Access Compliance Report

Public Rights-of-Way

(Curb Ramps)

Intersection ID: 2954	Main Street: GREEN_HEDGE_AV	Cross Street: SWEET_ROSE_CT	Location:	N
ADA ID: AAFEE1DD5F66	Ramp Type: Perp	Initial Pass/Fail: Fail	Overall Compliance: No	Severity Score: 12.5
Codes/Mitigation Info/Possible Solution		Field Measurements/Component Compliance

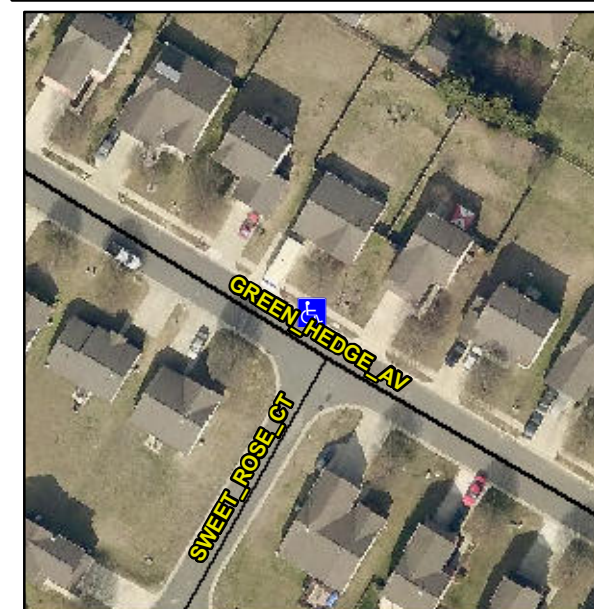
R304.2.2

Compliance	Description	Data	Compliance	Description	Data
N/A	Ramp Length (in)	48.0	No	Ramp Slope (%)	8.8
Yes	Ramp Width (in)	48.0	Yes	Ramp XSlope (%)	0.7
N/A	Flare Type LT	N/A	N/A	Flare Type RT	N/A
N/A	Flare Slope LT (%)	N/A	N/A	Flare Slope RT (%)	N/A
N/A	Flare Traversable LT?	N/A	N/A	Flare Traversable RT?	N/A
N/A	Landing Length (in)	N/A	N/A	DWS Provided?	N/A
N/A	Landing Width (in)	N/A	N/A	DWS Contrast?	N/A
N/A	Landing Slope (%)	N/A	N/A	DWS Length (in)	N/A
N/A	Landing X Slope (%)	N/A	N/A	DWS Full Width?	N/A
N/A	Landing Curb? (Y/N)	N/A	N/A	DWS Offset (in)	N/A
N/A	Shared Landing?	N/A			
N/A	Gutter Ponding?	N/A	N/A	Gutter Slope (%)	N/A
N/A	Gutter Lip Ht (in)	N/A	N/A	Gutter X Slope (%)	N/A
N/A	Painted X Walk1?	No	N/A	Painted X Walk2?	N/A
	X Walk 1 Direction	To SW		X Walk 2 Direction	N/A
N/A	X Walk 1 Width (in)	N/A	N/A	X Walk 2 Width (in)	N/A
	X Walk 1 Slope (%)	4.0		X Walk 2 Slope (%)	N/A
	X Walk 1 X Slope (%)	1.5		X Walk 2 X Slope (%)	N/A

Remove & Replace Entire Ramp.
